**THE PORT AUTHORITY OF NEW YORK AND NEW JERSEY
TWO MONTGOMERY STREET - 1st FLOOR
JERSEY CITY, NJ 07302**

ADDENDUM NO. 8

TO PROSPECTIVE BIDDERS ON CONTRACT **EW-154.395** – NEWARK LIBERTY INTERNATIONAL AIRPORT – TERMINAL A REDEVELOPMENT PROGRAM BRIDGES N61, N62, N63, AT-GRADE ROADWAYS AND APPURTENANCES AND CONTRACT **EW-154.395M** – NEWARK LIBERTY INTERNATIONAL AIRPORT – AGREEMENT TO PERFORM LANDSCAPE MAINTENANCE

SKETCH SK-S01
ADDENDUM NO. 8

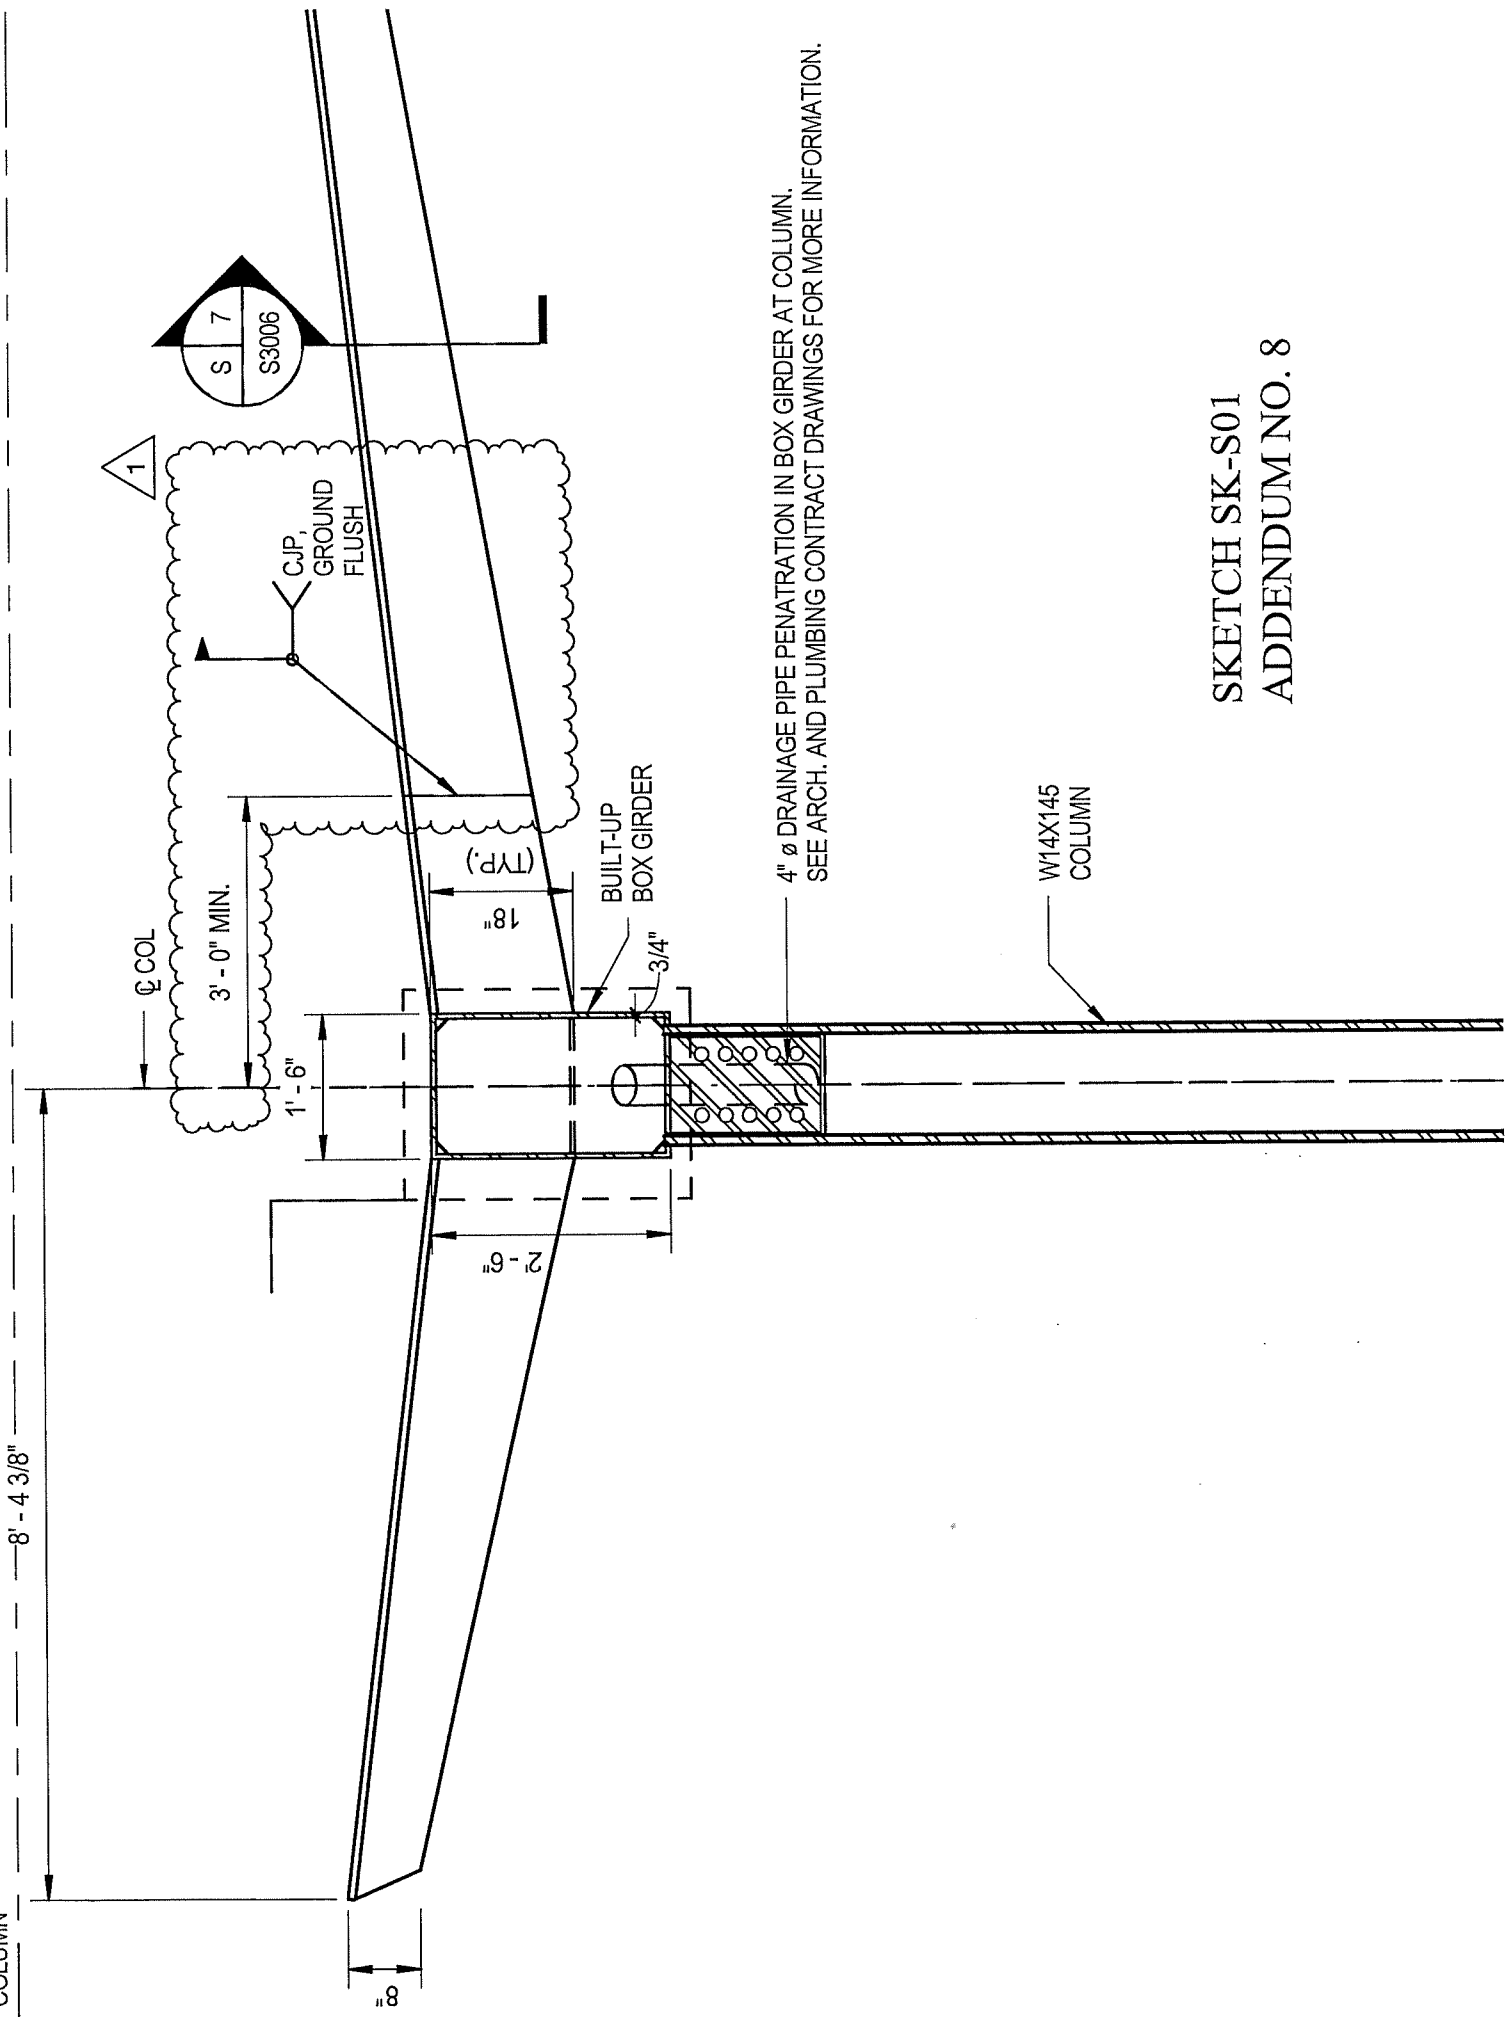
- Dwg. S3003 - Revise the drawing as shown in Sketch SK-S01 which is attached hereto and made a part hereof.
- Dwg. S5201 - Immediately following the last sentence of Note 1, insert "ELEVATIONS ON REFERENCE DRAWINGS FROM CONTRACT NA520.069 ARE REFERENCED TO THE FACILITY VERTICAL DATUM. CONVERT TO THE NORTH AMERICAN VERTICAL DATUM OF 1988 (NAVD88) BY SUBTRACTING 298.457."

SKETCH SK-T01
ADDENDUM NO. 8

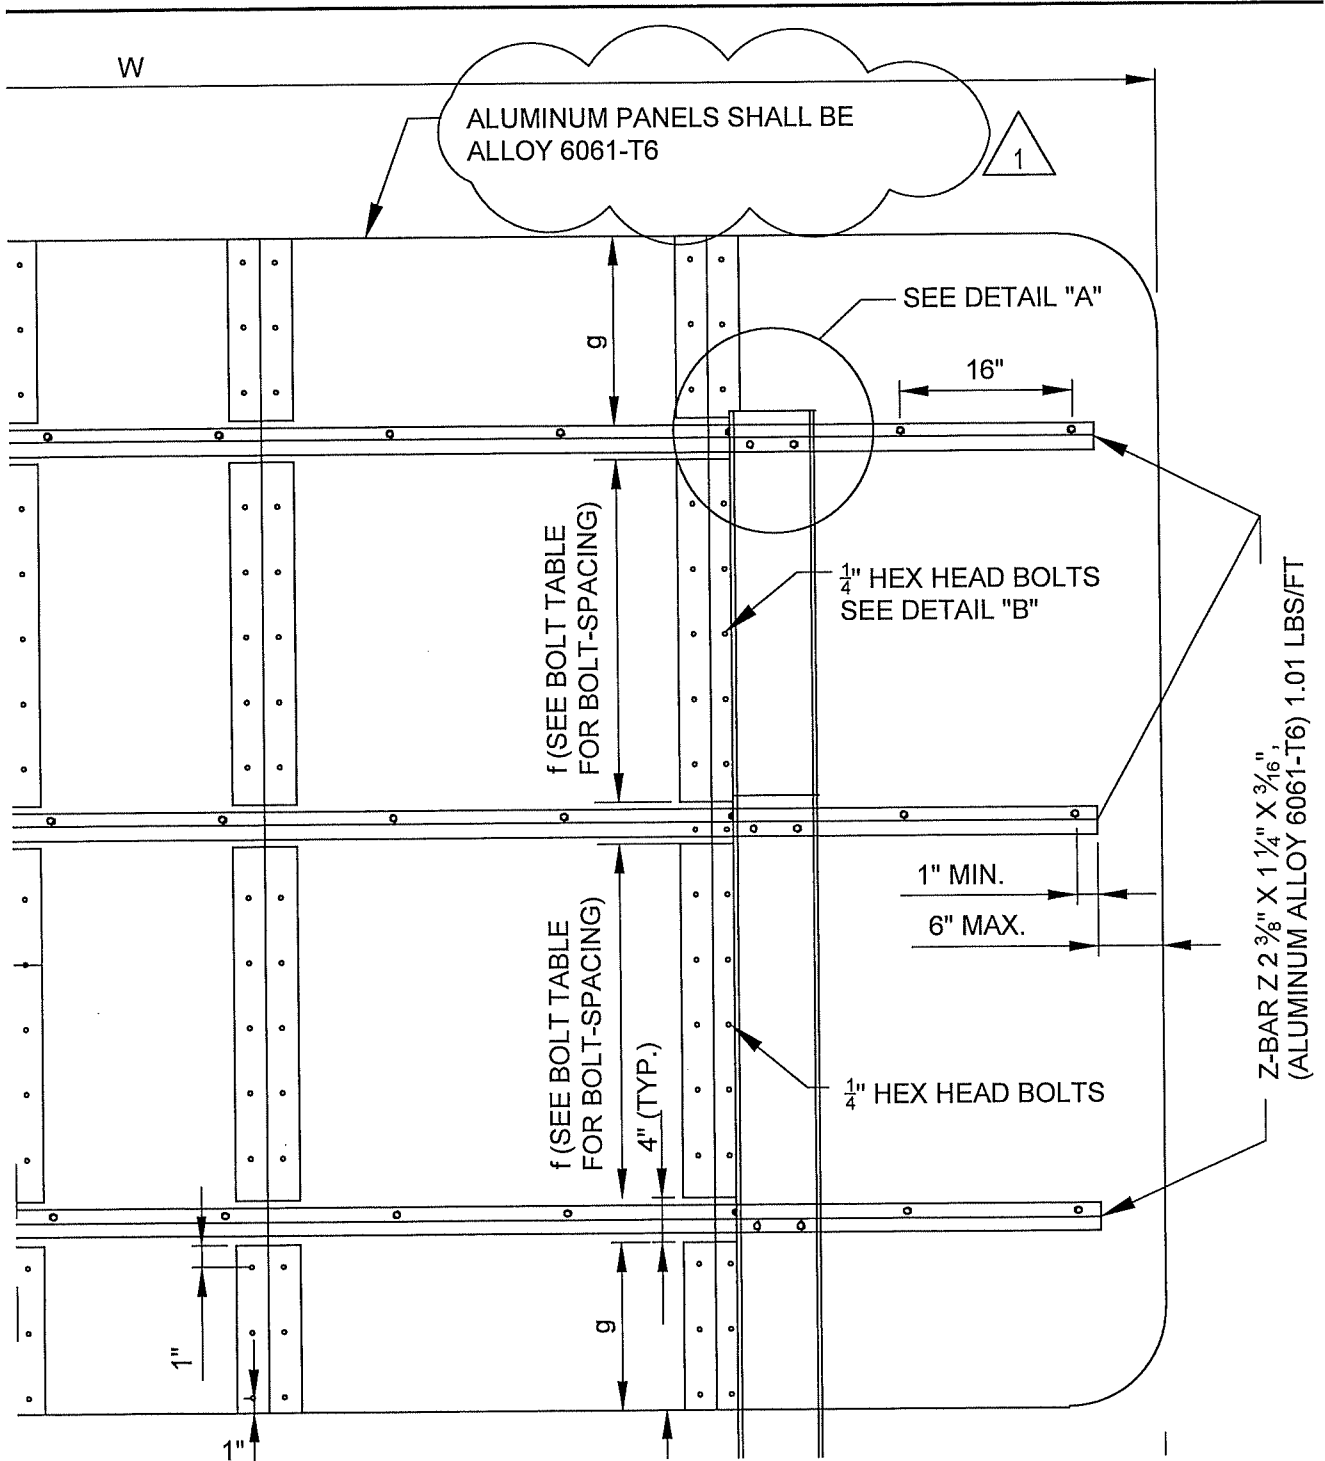
Dwg. T0101 - Revise the drawing as shown in Sketch SK-T01 which is attached hereto and made a part hereof.

SKETCH SK-T02
ADDENDUM NO. 8

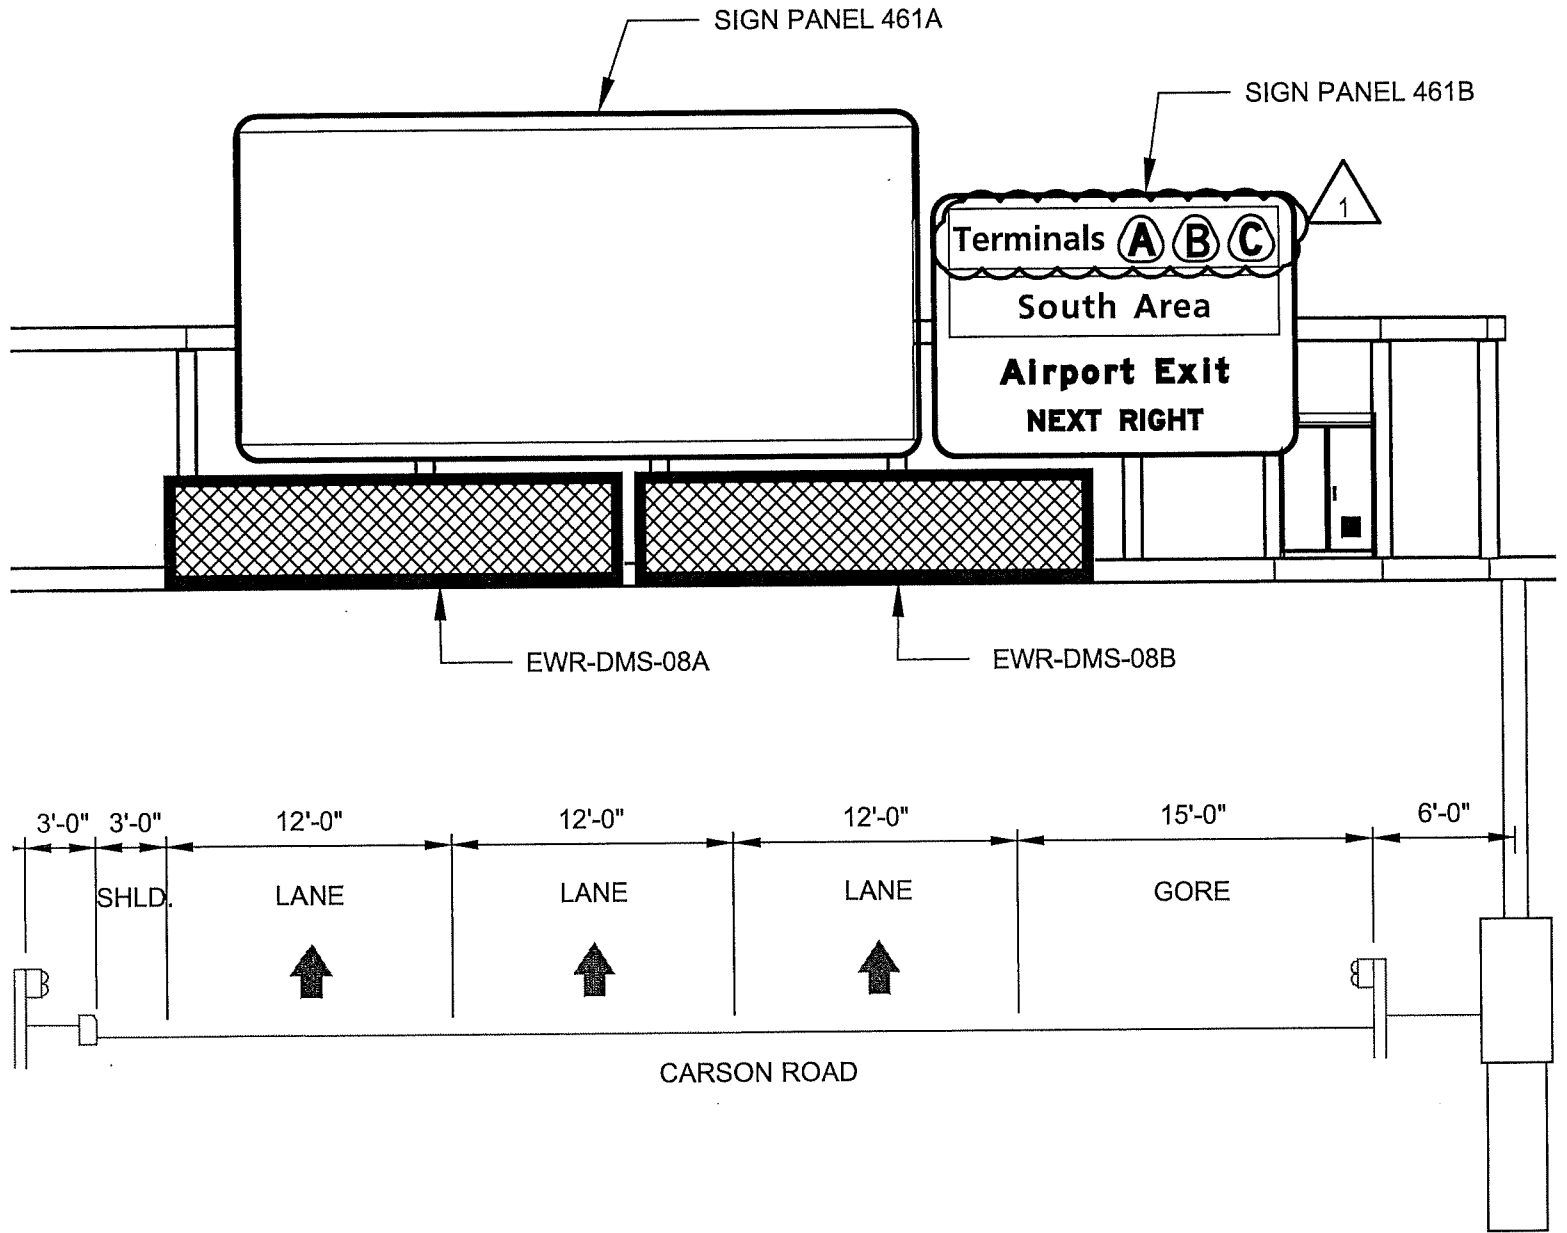
Dwg. T0406 - Revise the drawing as shown in Sketch SK-T02 which is attached hereto and made a part hereof.

SKETCH SK-T05
 ADDENDUM NO. 8

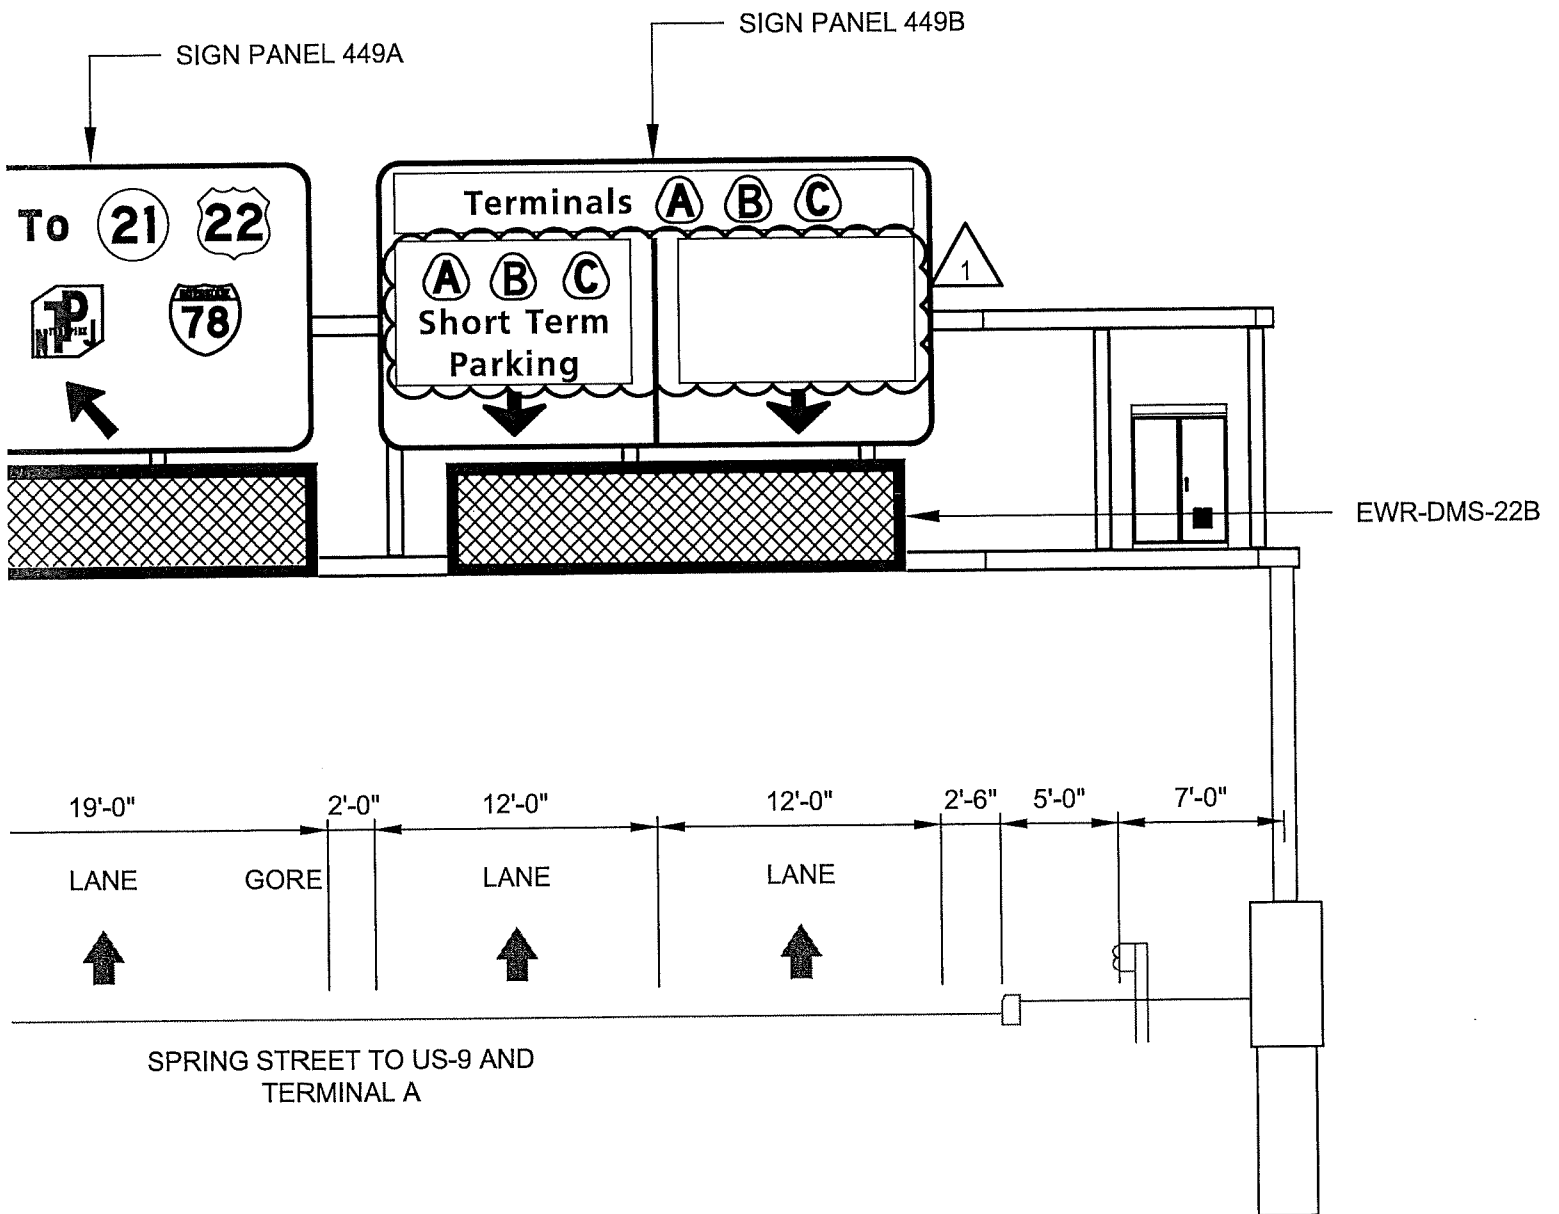
Dwg. T0533 - Revise the drawing as shown in Sketch SK-T05 which is attached hereto and made a part hereof.
